20-091MPR & 20-115MSP – IVYBROOK ACADEMY

Review and approval of a Parking Plan, Waiver and Master Sign Plan for a daycare (pre-school only) use on the 0.97-acre lot.

20-091MPR & 20-115MSP
Parking Plan & Master Sign Plan
Ivybrook Academy
3755 Dublin-Granville Road

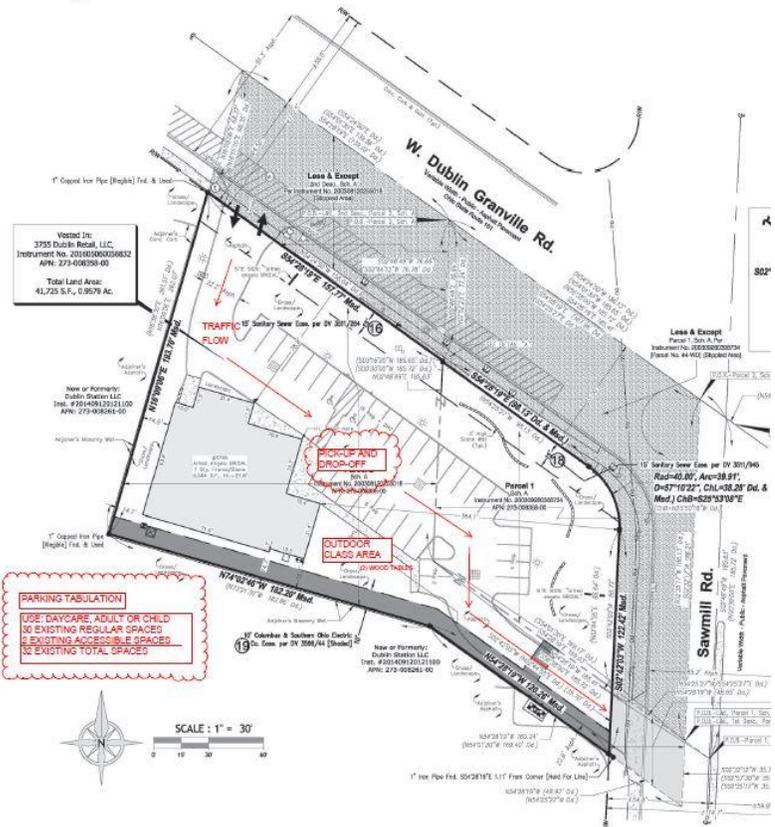
In conjunction with the pre-school, the applicant is proposing an outdoor classroom, which is located east of the building. Given the use classification as a 'Day Care, Adult or Child'. The use classification has associated use specific standards defined in Zoning Code Section 153.059(C)(2)(c). The use specific standards require that "Outdoor recreation areas shall be located to the side or rear of a principal structure and be enclosed with a perimeter fence. The outdoor recreation area shall be screened using fencing and/or landscaping to provide a minimum 50% opaque screen". Given that the Code does not contemplate an outdoor classroom, the area is considered an outdoor recreation area. The area is proposed to be located forward of the building given the existing site layout. The Waiver request is to permit the location of the outdoor classroom.

Unlike a typical outdoor recreation area, the outdoor classroom is not proposed to have any play equipment. The proposal includes two wood tables. To meet the requirements of the use specific standards the area should be enclosed with a 4-foot tall, wrought-iron-style, black metal fence. The area should also be screened with evergreen hedges, subject to Staff approval. The associated site furnishing details should be subject to Staff approval and constructed of high-quality, weather resistant materials.

- 1) The applicant enclose the outdoor recreation with a 4-foot tall, wrought-iron-style, black metal fence, and screen the area with evergreen landscaping, subject to Staff approval.
- 2) The applicant provide furniture details for the outdoor recreation area, subject to Staff approval.
